Access Compliance Report Public Rights-of-Way (Curb Ramps)

Main Street: NEWPORT_AVE Cross Street: WINDSOR_LN Location: SE

ADA ID: RPAT211027115656 Ramp Type: Type 1 - Perpendicular Diagonal Initial Pass/Fail: Fail Overall Compliance: No Severity Score: 2

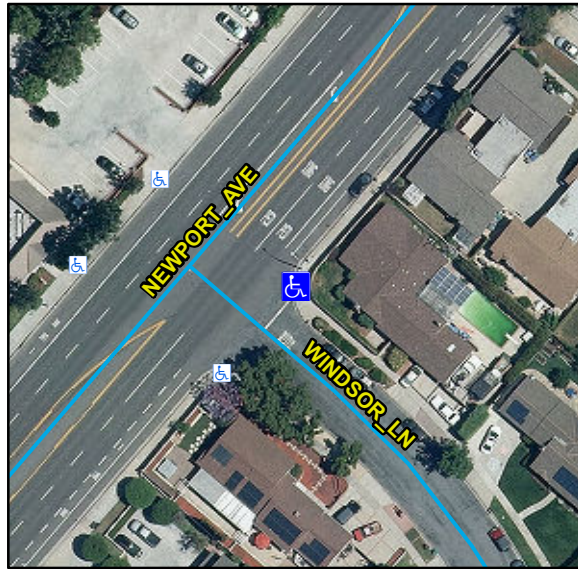
Compliance	Description	Data	Compliance	Description	Data
N/A	Ramp Length (in)	50	N/A	Flare Type LT	
Yes	Ramp Width (in)	48			N/A
Yes	Ramp Run Slope (%)	8	N/A	Flare Slope LT (%)	N/A
No	Ramp Cross Slope (%)	2.8	N/A	Flare Traversable LT	N/A
N/A	Landing Present	N/A	N/A	Flare Type RT	
N/A	Landing Length (in)	N/A			N/A
N/A	Landing Width (in)	N/A	N/A	Flare Slope RT (%)	N/A
N/A	Landing Run Slope (%)	N/A	N/A	Flare Traversable RT	N/A
N/A	Landing Cross Slope (%)	N/A	N/A	DWS Provided	N/A
N/A	Landing Movement Obstructed?	N/A	N/A	DWS Contrast	N/A
	Landing Movement Type	N/A	N/A	DWS Length (in)	N/A
N/A	Landing Shared	N/A	N/A	DWS Full Width	N/A
N/A	Clear Space	Yes	N/A	DWS Offset Left (in)	N/A
N/A	Clear Space To Crosswalk (in)	N/A	N/A	DWS Offset Right (in)	N/A
N/A	Marked Crosswalk 1	No	N/A	Marked Crosswalk 2	No
	Crossing 1 Direction	NW		Crossing 2 Direction	SW
	Marked Crosswalk 1 Width (in)	N/A		Marked Crosswalk 2 Width (in)	N/A

N/A	Ramp Inside Crosswalk 1	N/A	Yes	Ramp Inside Crosswalk 2	N/A
	Crossing 1 Slope (%)	7.5		Crossing 2 Slope (%)	2.8
	Crossing 1 Cross Slope (%)	1.1		Crossing 2 Cross Slope (%)	4.9
N/A	Gutter Ponding	N/A	No	Curb Slope	9
Yes	Gutter Lip Height (in)	0		Road Run Slope (%)	4.5
N/A	Gutter Run Slope (%)	N/A		Road Cross Slope (%)	5.4
N/A	Gutter Cross Slope (%)	N/A			
Yes	Overall Surface Condition: Acceptable		Yes	Perp Joint Present	Yes
	Cross Gutter Present?	No		Spandrel Present?	No
	Replace Cross Gutter?	N/A		Replace Spandrel?	N/A

Remove & Replace Curb Ramp With Two New Directional Ramps or Equivalent.
